## Appendix 3

Urban Design Review Panel Meeting
Proposed Development - Retirement Village and Residential Aged Care
Facility
Address - Lot 3990 Jordan Springs Boulevard JORDAN SPRINGS NSW
2747

Urban Design Review Panel Advice
Date of Issue	12 April 2018
Reference	UDRP18/0009
Proposal	Retirement Village and Residential Aged Care Facility
Address	Lot 3990 Jordan Springs Boulevard JORDAN SPRINGS NSW 2747
Key Issues	The following key issues were raised for address in the progression of the development proposal and the lodgement of a development application.
	Retirement Village (Independent Living Units)
	The vehicular access arrangements into the site require further consideration. Opportunities exist for an east / west connection from Lakeside Parade through the site terminating with direct views into the lake. This connection should be further explored as the layover and road alignment is unlikely to impact on the delivery of the adjacent approved development.
	<ul> <li>The provision of a road connection also enable a better 'sense of address' for the site as well as the ability to better connect the proposed future aged care living development with the broader retirement village p

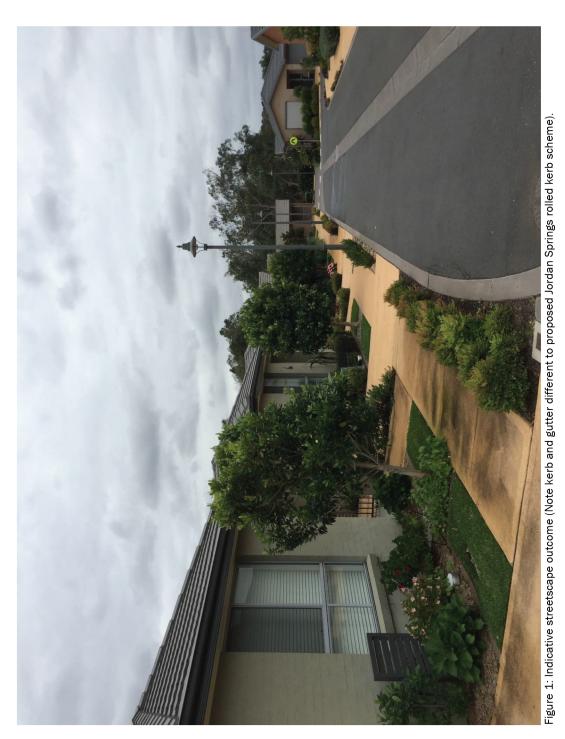
80	•	The configuration of the road pattern and the resulting unit locations / orientations is creating poor solar access outcomes through the centre of the development. The configuration also provides a potential 'dead space' between villages in the centre of the development. The space east of the cul-de-sac head	• •	The configuration of the road pattern and unit locations have been amended and improved. Solar access has been improved by relocating the multi storey units south of the villas. The

:			
#	UDRP comments	Res	Kesponse
	does not provide sufficient opportunities for activation and does not have		past configuration had the ILAs west facing,
	identifiable access from a key roadway. The design of this space and the		they are now all North/South facing.
	intended use and the configuration requires amendment. Relocation of the	•	The communal open space (identified by the
	multi storey form may assist with the configuration of units, the orientation of		UDRP as a 'potential dead space') between the
	the lots to maximise solar access and unit separation.		villages has been removed.

Figure 3: Indicative streetscape outcome (Note kerb and gutter different to proposed Jordan Springs rolled kerb scheme).

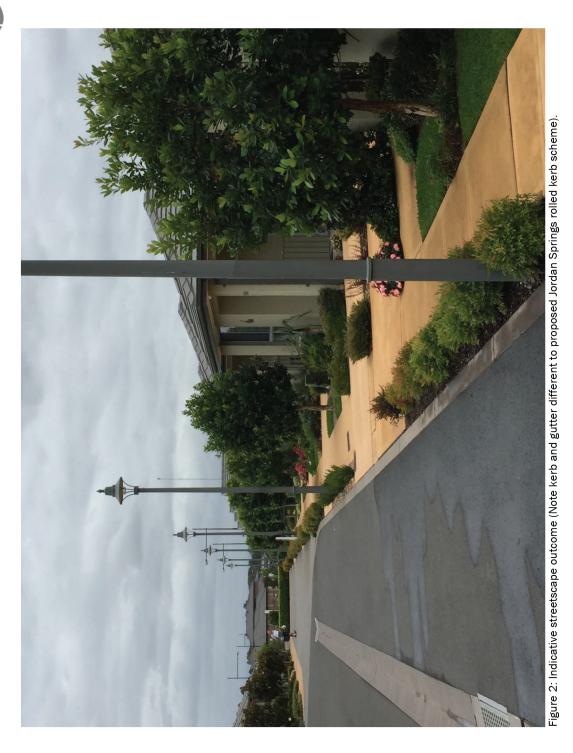
Jordan Springs Boulevard and the villas.
11	<ul> <li>The driveway separations (south of Jordan Springs Boulevard) and double width</li> </ul>	•	The total number of villas have been reduced
	areas provide excessive hard stand areas, compromising landscape and street		from 64 to 51, which reduces the overall
	tree outcomes. Split driveways suitable separated by landscaping must be		amount of hard stand areas.
	provided noting on street parking requirements need to be considered (in terms	•	Double width driveways have been reduced
	of separation distances between driveways).		from 19 to 16.

•	This will achieve a satisfactory streetscape
			outcome. Please see photos below for
			indicative streetscape outcomes.
12	<ul> <li>The location of parking bays appears irregular and inaccessible. The location of visitor parking should be carefully considered ensuring that suitable provision is</li> </ul>	•	Two visitor parking areas have been proposed.
	עוסונין אמואיים איים איים איים איים איים איים איים
